Access Compliance Report

Public Rights-of-Way

Intersection ID: 52589	Main Street: BURNETTE_AV	Cross Street: TRIUMPH_DR	Location: SE
ADA ID: 8C51DC3328DA	Ramp Type: BlendTrans1	Initial Pass/Fail: Pass	Overall Compliance: No
		Severity Score: 0.25

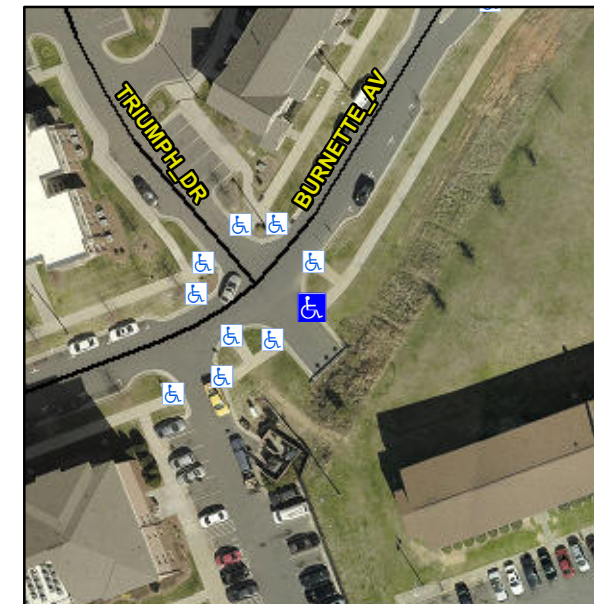
R304.5.3

Compliance	Description	Data	Compliance	Description	Data
N/A	Ramp Length (in)	72.0	Yes	BlendTrans Slope (%)	4.6
Yes	Ramp Width (in)	70.0	No	BlendTrans XSlope (%)	3.5
Yes	Flare Type L	Curbed_NoWalkSurface	Yes	Flare Type R	Curbed_NoWalkSurface
N/A	Flare Slope LT (%)	N/A	N/A	Flare Slope RT (%)	N/A
N/A	Flare Traversable LT?	No	N/A	Flare Traversable RT?	No
Yes	Landing Length (in)	57.0	Yes	DWS Provided?	Yes
Yes	Landing Width (in)	70.0	Yes	DWS Contrast?	Yes
Yes	Landing Slope (%)	1.0	Yes	DWS Length (in)	24.0
No	Landing X Slope (%)	2.4	Yes	DWS Full Width?	Yes
N/A	Landing Curb? (Y/N)	No	Yes	DWS Offset (in)	0.0
N/A	Shared Landing?	No			
Yes	Gutter Ponding?	No	Yes	Gutter Slope (%)	0.3
Yes	Gutter Lip Ht (in)	0.0	Yes	Gutter X Slope (%)	0.8
N/A	Painted X Walk1?	No	N/A	Painted X Walk2?	N/A
	X Walk 1 Direction	To SW		X Walk 2 Direction	N/A
	X Walk 1 Width (in)	N/A		X Walk 2 Width (in)	N/A
	X Walk 1 Slope (%)	0.4		X Walk 2 Slope (%)	N/A

Remove & Replace Curb Ramp With Two New Directional Ramps or Equivalent.
